This application has been prepared by Ethos Urban on behalf of Infrastructure NSW pursuant to Section 4.55(1A) of the *Environmental Planning and Assessment Act 1979* (EP&A Act) to modify Development Consent SSD 10416 relating to the Powerhouse Parramatta at 34-54 and 30B Phillip Street and 338 Church Street, Parramatta (the site).

The purpose of this modification is to amend State Significant Development Consent SSD 10416 to accommodate the redevelopment of the St George's Terrace, as well as subsequent design refinements to the rooftop pavilion of the eastern building.

**Figure 1 Modifications to Rooftop Pavilion**

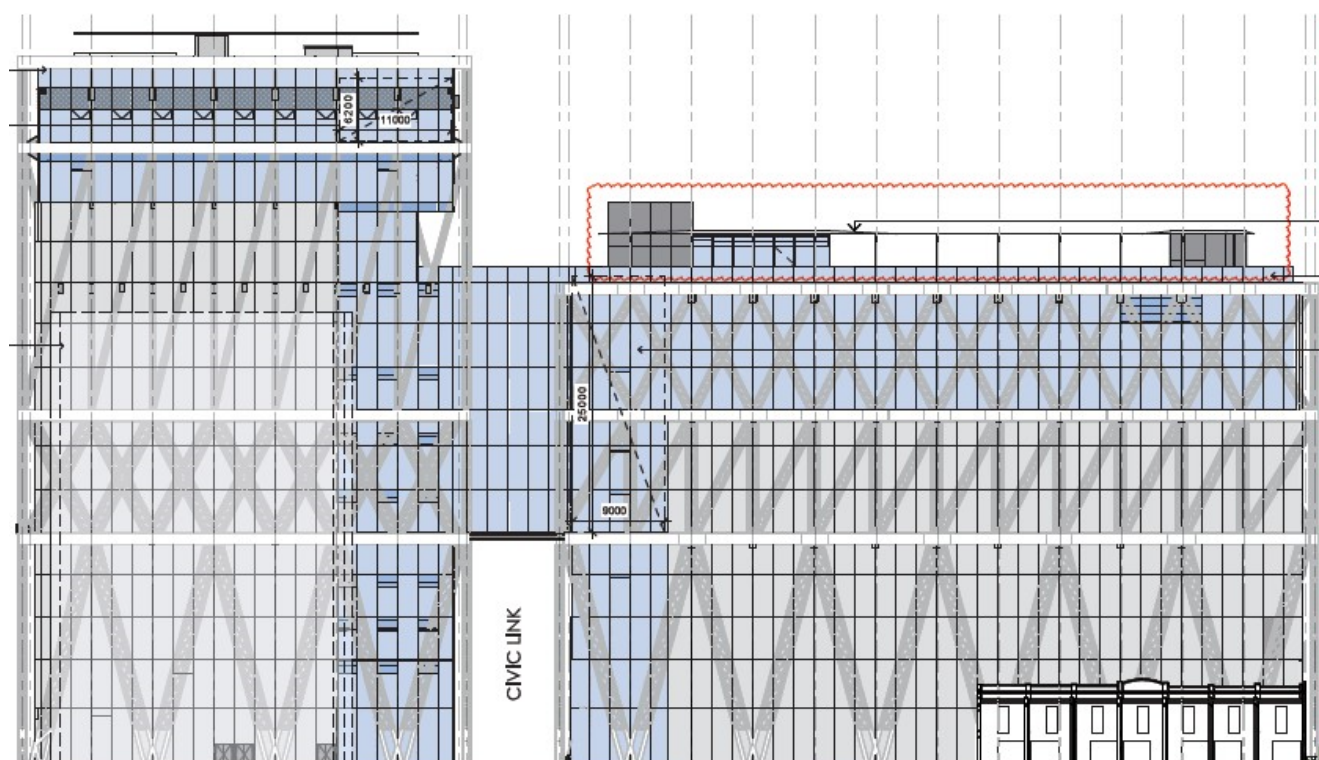
In order to minimise the visual impact of the back-of-house and services equipment, this modification application seeks to provide an enlarged pavilion roof, which will improve weather protection to allow improved usage of this space and to connect the different activity zones on the rooftop. This will result in minor increase in the building height by approximately 2 metres, however, the built form will remain well below the maximum building height for the site permitted under the *Parramatta Local Environmental Plan 2011*.

The architectural expression of this canopy is discrete and setback from the building parapet, and will not result in any significant environmental impacts. A large opening over the central garden is also provided to create a connection to the sky and sun, which will also allow for taller planting on the roof.

**Figure 1** below illustrates the proposed design revisions to the rooftop pavilion. **Figure 2** and **Figure 3** provide photomontages that clearly illustrate the proposed design of the rooftop pavilion in comparison to the approved design.

- (a) Western Building must not exceed RL 79.2m.
- (b) Eastern Building must not exceed RL ~~60.8m~~ **62.65m**.

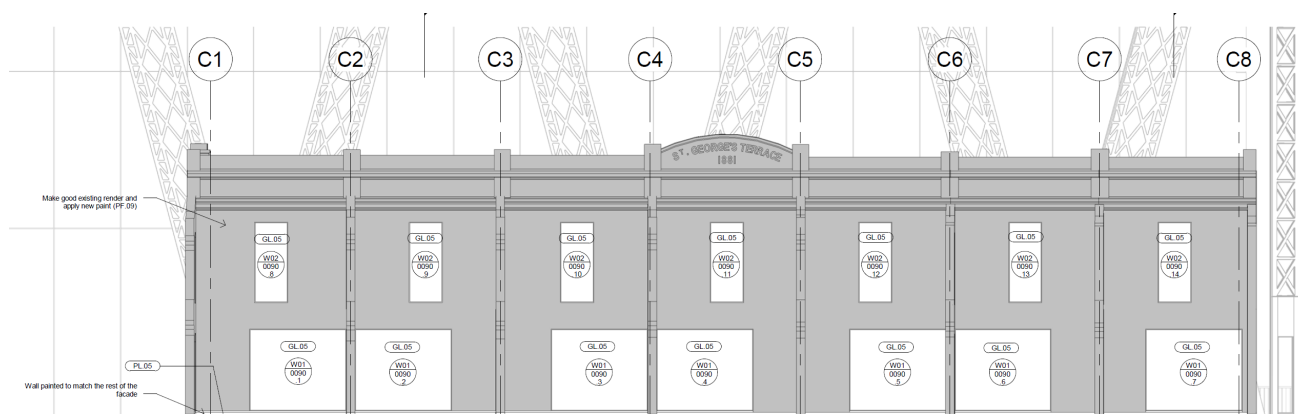
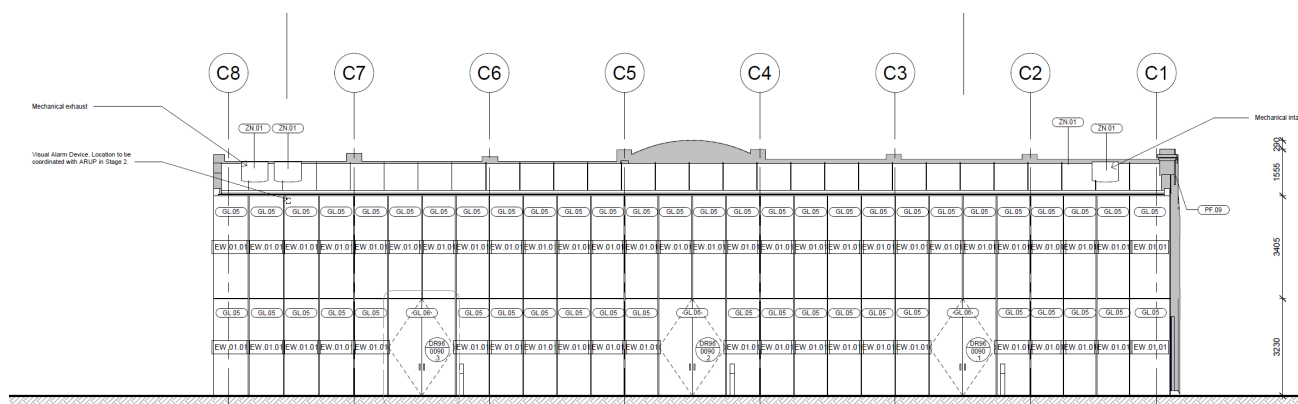
The proposed modification will retain and conserve the significant heritage fabric of the Terrace. Unsympathetic and intrusive contemporary alterations and additions that have been made to the building over time would be largely demolished in order to enhance integration into the site and to create a functional space for the Powerhouse programming. The proposal will accommodate a single, adaptable, double-height space that is flexible and will support different programmatic scenarios. A concealed kitchenette and amenities are located at the eastern end of the terrace to support the internal functions of the space.

The design of the space is minimalistic to allow for the retention and celebration of the remaining heritage fabric. The space will connect to the surrounding public domain through doorways to the west (onto Phillip Street Plaza) and to the north, and extensive areas of glazing on the northern façade, creating an activated laneway between the terrace and Presentation Space 1. The modern doorways and windows to Phillip Street will be retained in aperture, but infilled with higher grade glazing, allowing views to the interior and activating Phillip Street. The main access point will be through the western and northern doorways, to ensure the primacy of the main museum entrance within the western building for wayfinding. The Terrace's will adopt a similar material palette to the main development, whilst distinguishing itself through its scale and its heritage form and proportion.

**Figure 5 to Figure 7** illustrate the proposed floor plan and both the southern elevation to Phillip Street and the northern elevation to the Laneway. As seen below, the heritage façade of the Terrace is being conserved as part of the redevelopment.
